# Humanetics Innovative Solutions, Inc.

## Dimensional Tolerance Review Flex PLI

IG GTR9-PH2 9<sup>th</sup> Meeting

# Review to Overall Flex PLI Leg length Tolerance

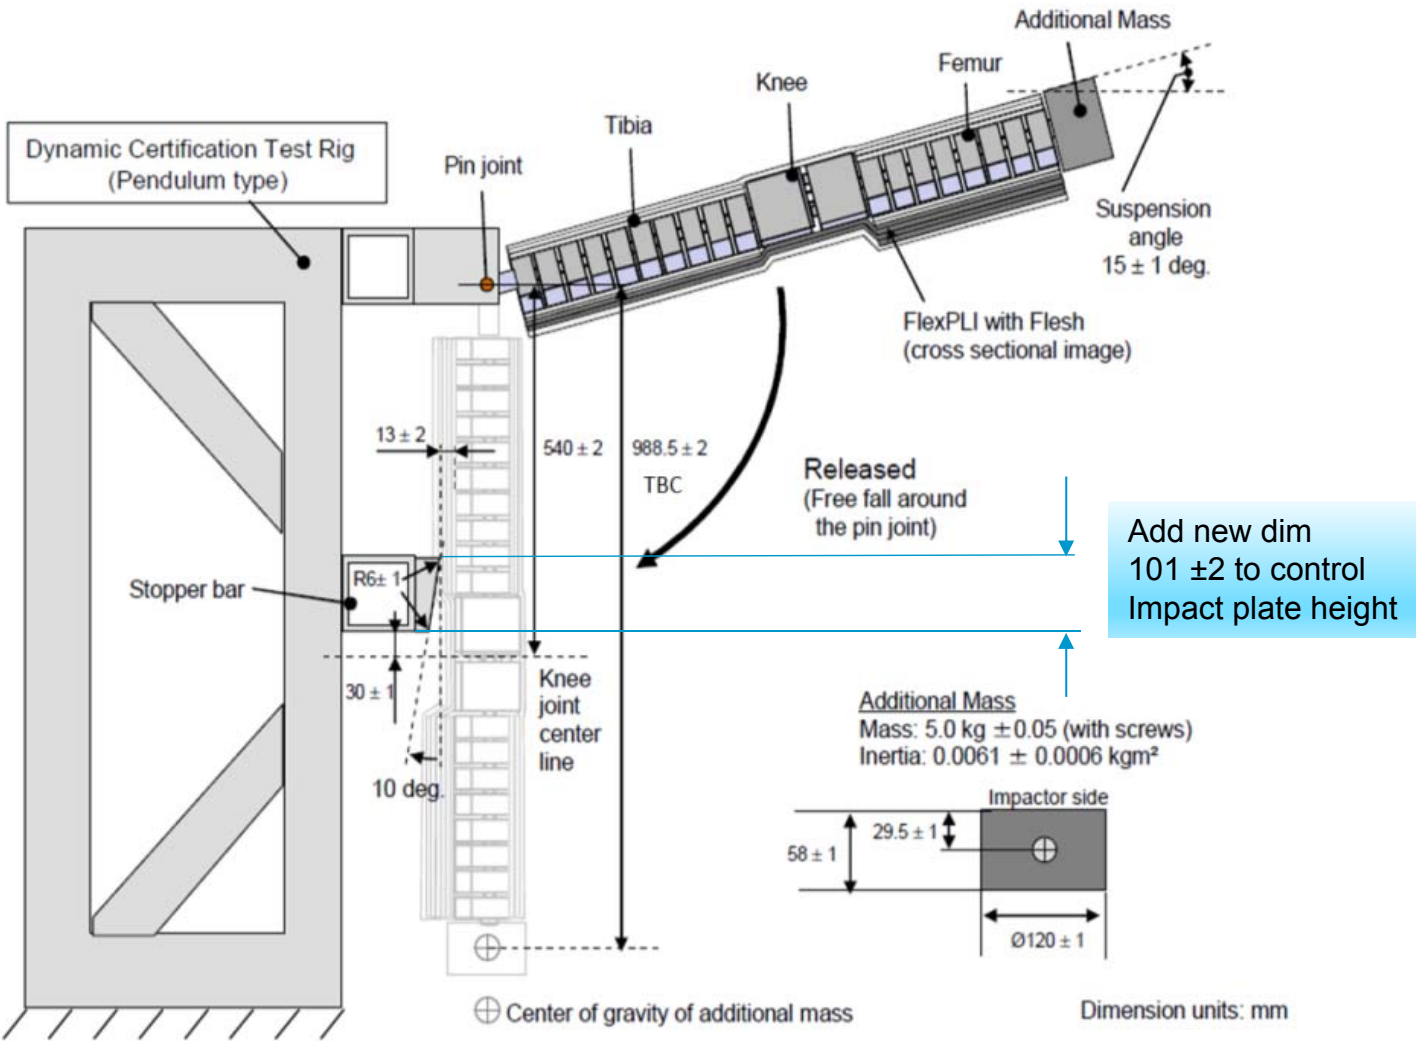
- ▶ It has been observed that the  $\pm 3$  tolerance on the 928 overall leg length tends to be on the high side of the tolerance. Some recorded values are shown below.
- ▶ Due to segment buffers slightly under compression, all component play in the links leans towards leg elongation
- ▶ It is also expected the leg will stretch slightly with use as parts wear
- ▶ Humanetics will review new and used legs to confirm this issue
- ▶ A positive shift to the tolerance like  $-2/+4$  could be an option

Measured Dim	Relation to Tolerance
931	+3
931	+3
929.5	+1.5
929	+1
927	-1
929	+1
